SUBJECT: BELLEFONTE NUCLEAR PLANT, UNITS 1 AND 2 - STAFF ASSESSMENT OF INFORMATION PROVIDED PURSUANT TO TITLE 10 OF THE *CODE OF FEDERAL REGULATIONS* PART 50, SECTION 50.54(f), SEISMIC HAZARD REEVALUATIONS FOR RECOMMENDATION 2.1 OF THE NEAR-TERM TASK FORCE REVIEW OF INSIGHTS FROM THE FUKUSHIMA DAI-ICHI ACCIDENT (TAC NOS. MF3944 AND MF3945)

STAFF ASSESSMENT BY THE OFFICE OF NUCLEAR REACTOR REGULATION

RELATED TO SEISMIC HAZARD AND SCREENING REPORT

BELLEFONTE NUCLEAR PLANT, UNITS 1 AND 2

**Figure 3.2-1 Plot comparing the Staff's and the Licensee's Mean Control Point Hazard Curves at a Variety of Frequencies for the Bellefonte Site**

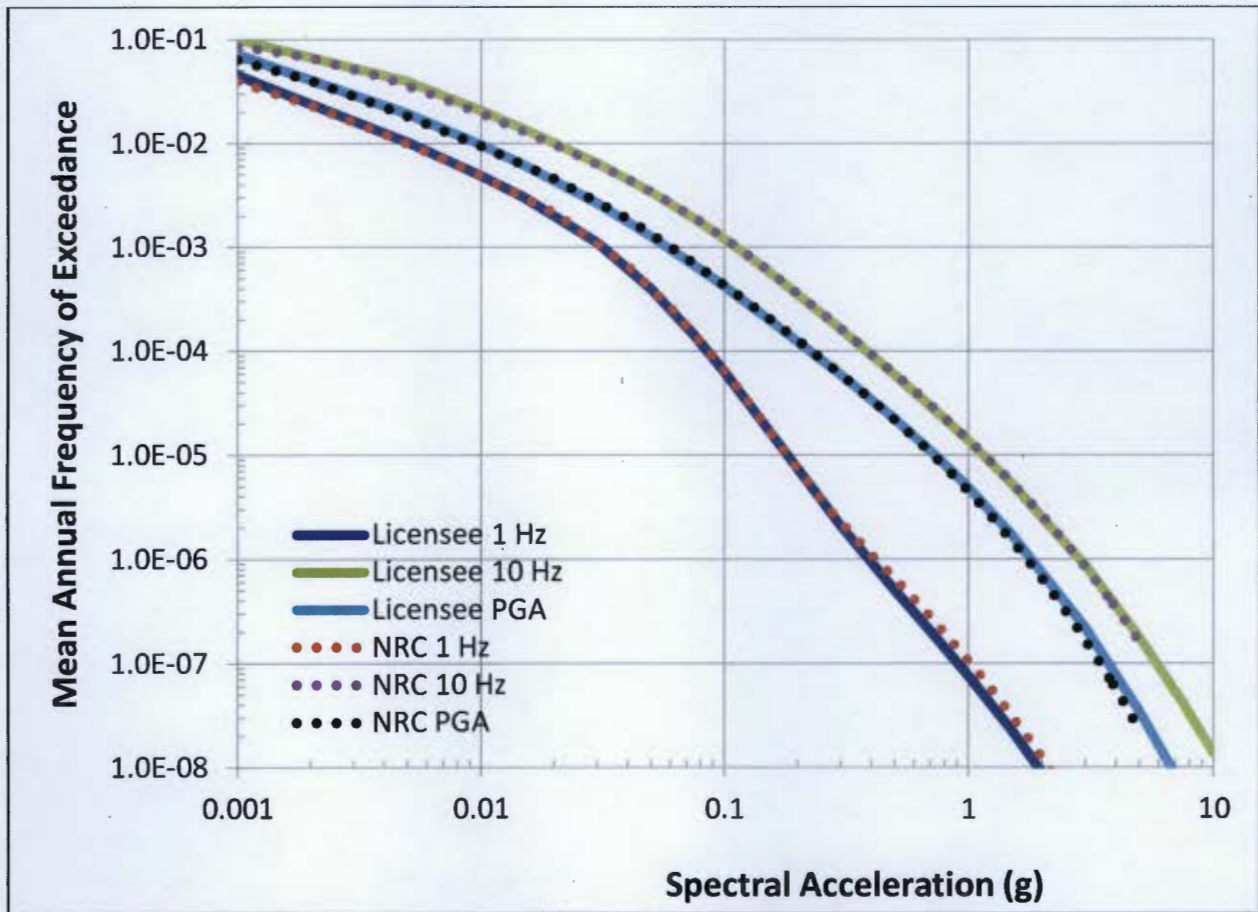
used the mid-continent version of the updated EPRI GMM (EPRI, 2013), except for the Extended Continental Crust-Gulf Coast (ECC GC) background seismic source. For the ECC GC source zone, the staff used the Gulf Coast version of the updated EPRI GMM (EPRI, 2013). Figure 3.2-1 of this assessment shows the hazard curves developed by the licensee and those developed by the staff using the CEUS-SSC at three of the seven spectral frequencies. As expected, the hazard curves developed by the licensee and the staff are similar at all frequencies.

Based on its review of the SHSR and the licensee's RAI response, the NRC staff concludes that the licensee appropriately followed guidance provided in the SPID for selecting the PSHA input models and parameters for the site. This includes the licensee's use and implementation of the CEUS-SSC model and the updated EPRI GMM.

**Figure 3.4-1 Comparison of the Staff's GMRS with Licensee's GMRS and the Bellefonte Units 1 and 2 SSE.**

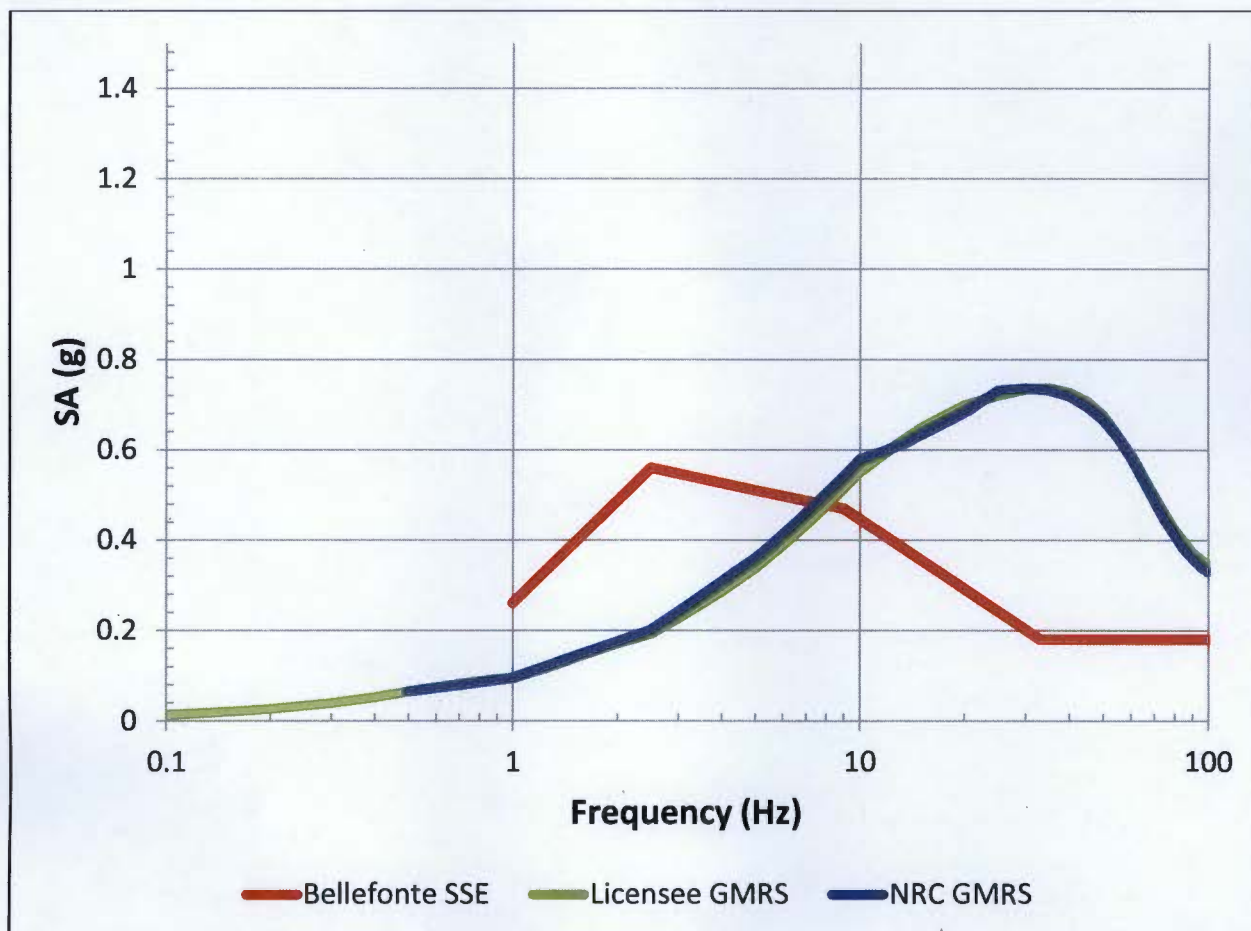
The NRC staff independently calculated the  $10^{-4}$  and  $10^{-5}$  UHRs using the results of its confirmatory PSHA, as described in Section 3.2 of this staff assessment. Figure 3.4-1 of this assessment shows a comparison of the GMRS determined by the licensee to that determined by the NRC staff. As shown in Figure 3.4-1 below, the licensee's GMRS shape and amplitude is nearly identical to that calculated by the NRC staff at all frequencies. The small differences that are present are attributed to differences in software used for hazard calculations.

The NRC staff confirms that the licensee used present-day guidance and methodology outline in RG 1.208 and the SPiD to calculate the horizontal GMRS, as requested in the 50.54(f) letter. The NRC staff performed a confirmatory PSHA and achieved results consistent with the licensee's horizontal GMRS. As such, the staff concludes that the GMRS determined by the licensee adequately characterizes the reevaluated hazard for the Bellefonte site. Therefore, this GMRS is suitable for use in subsequent evaluations and confirmations, as needed, for the response to the 50.54(f) letter.
